MODIFICATION MAJOR PROJECT No. 06-0243

PROPOSED MODIFICATION

STORMWATER PLANS

ENGINEERING REPORT

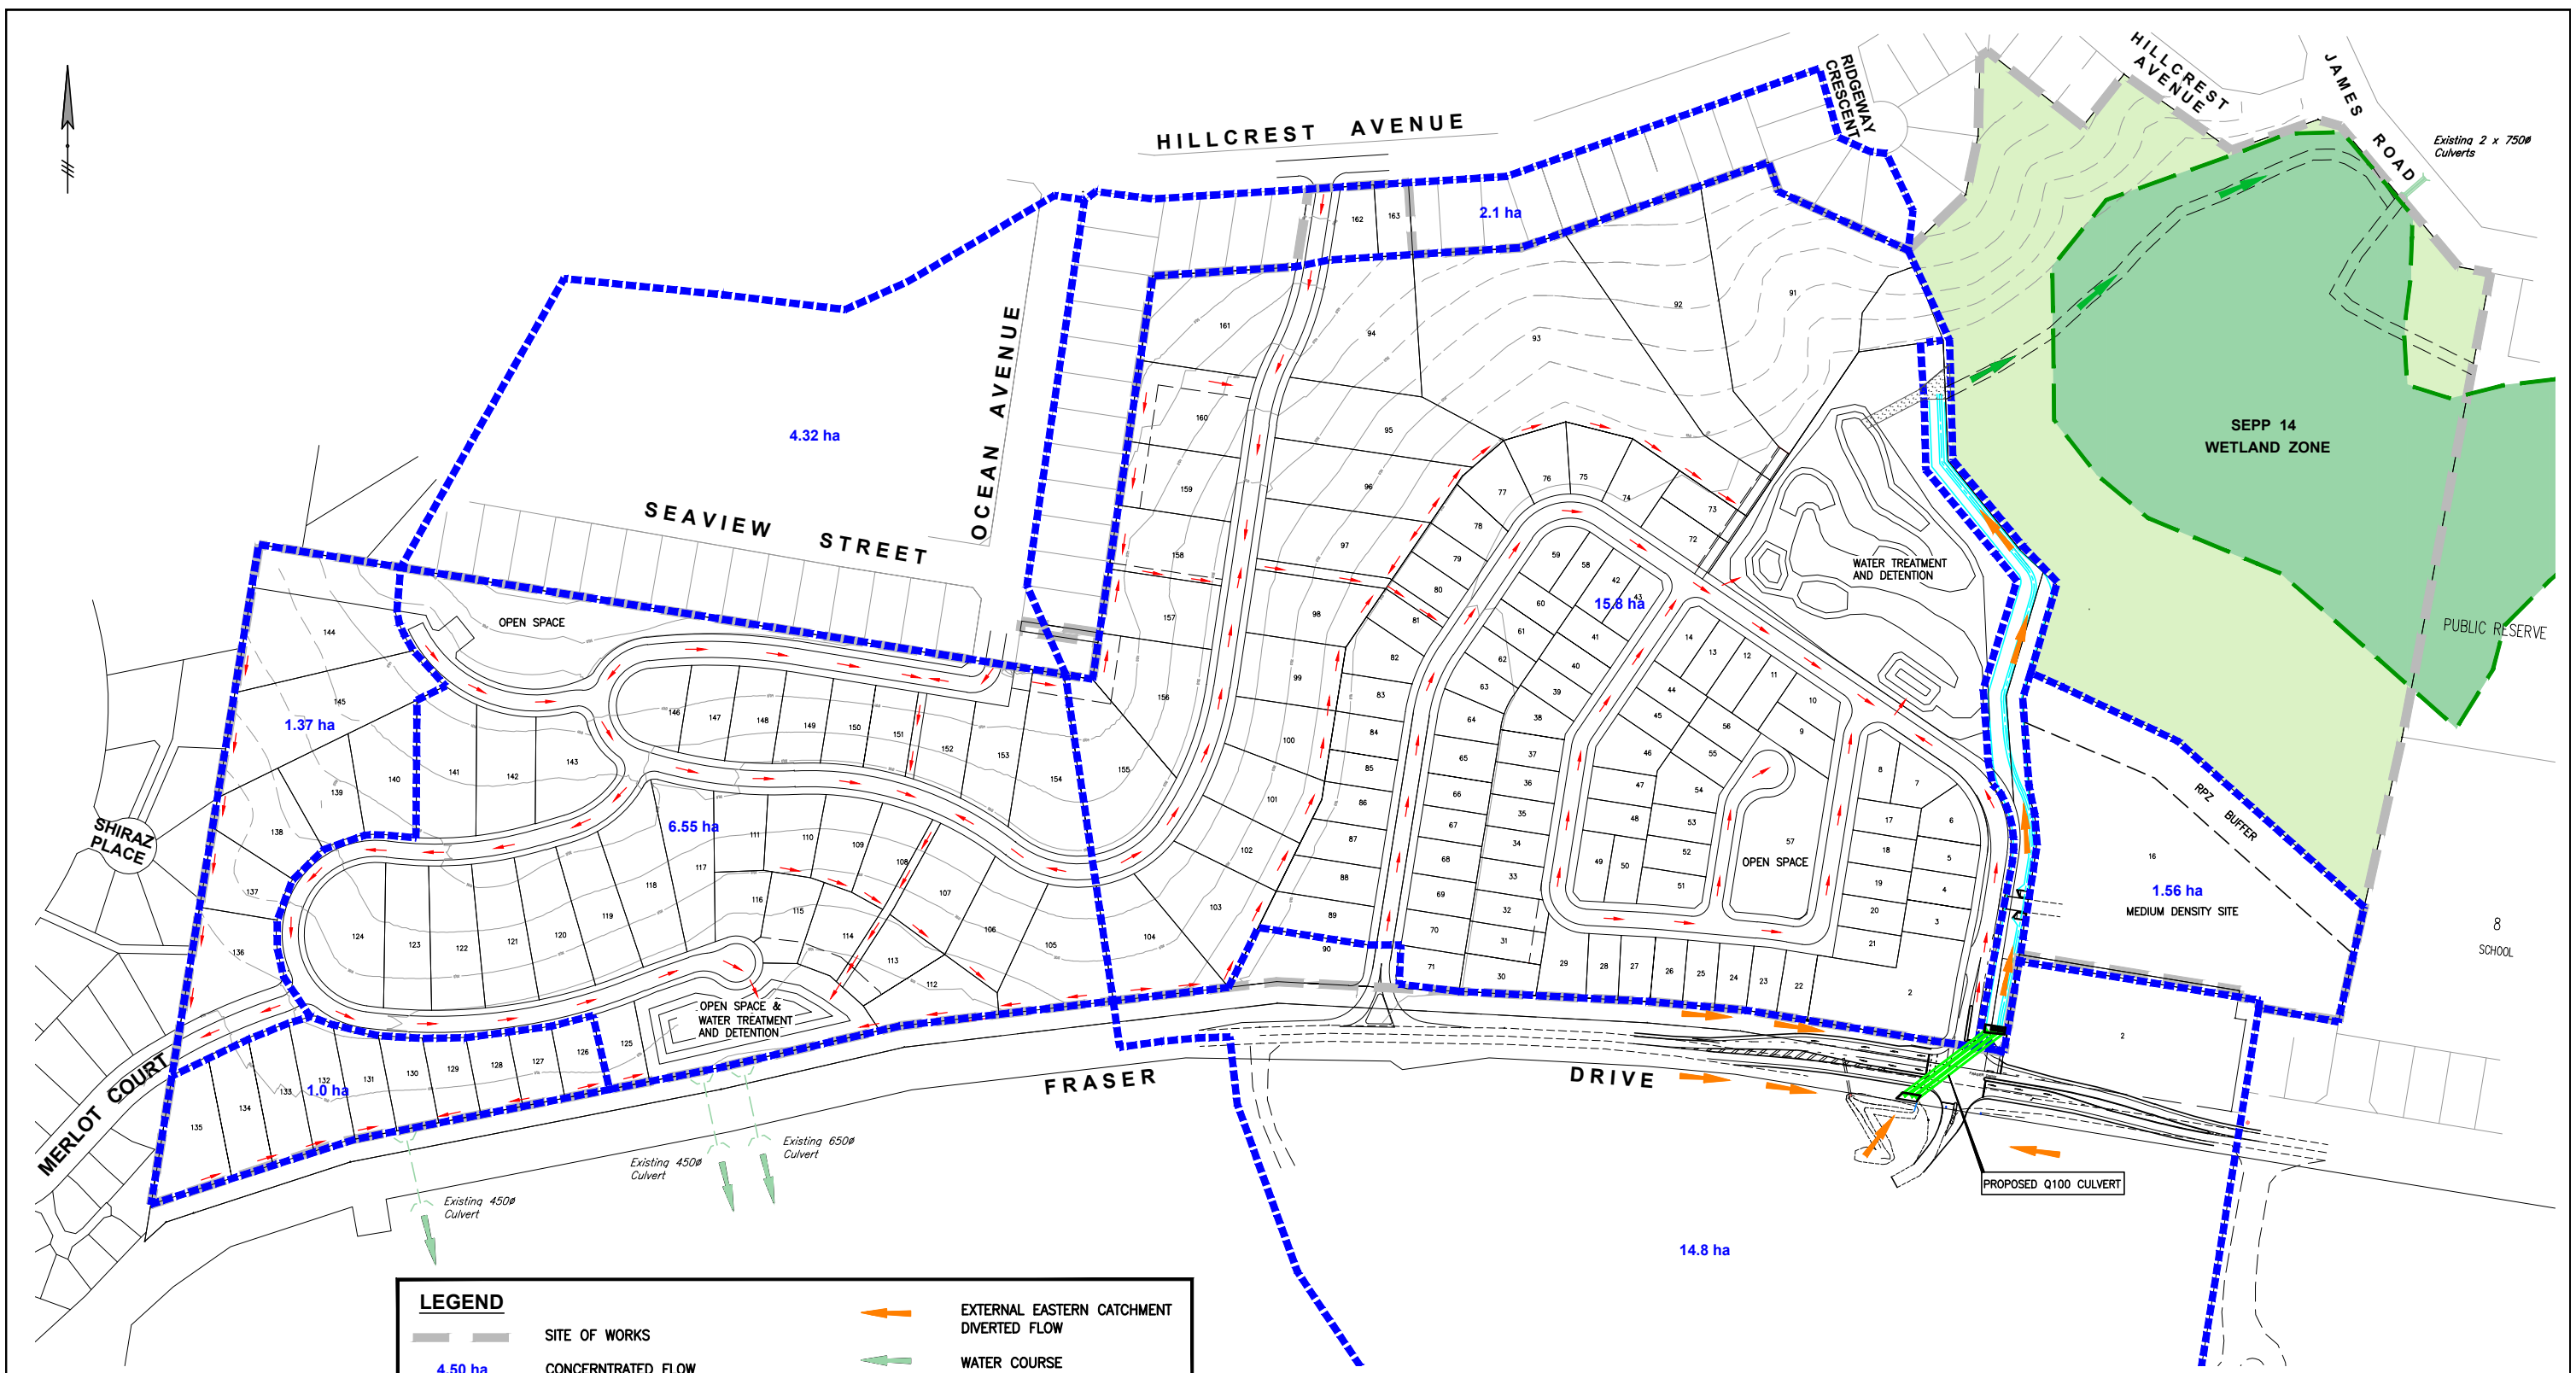
Modification of the stormwater system in the vicinity of the northern intersection to Fraser Drive from the project approved under Major Project No. 06-0243 is required to prevent adverse impacts to land east of Fraser Drive resulting from minimum design levels of Fraser Drive required by Tweed Shire Council.

The proposed changes reflected on VKL Consulting Pty Ltd Drawing Nos. 5536-10-SW1 & 5535-10-SW2 will mitigate potential stormwater drainage impacts arising as a consequence of requirements of Tweed Shire Council.

The stormwater drainage layout has been modified and provides Q100 capacity multi pipe culverts across Fraser Drive, ending within the existing Fraser Drive road reserve, layed at a level that is no higher than the existing 900mm dia pipe culvert that currently services the external catchment east of Fraser Drive.

Adjustment of some existing services in Fraser Drive will be required.

This Report addresses the potential impacts arising from Tweed Shire Council requirements and provides amended stormwater layout plans to replace the following Project Plans listed in A3 of the Project Approval.

VKL Consulting Pty Ltd - 5536-10-SW1

VKL Consulting Pty Ltd - 5536-10-SW2
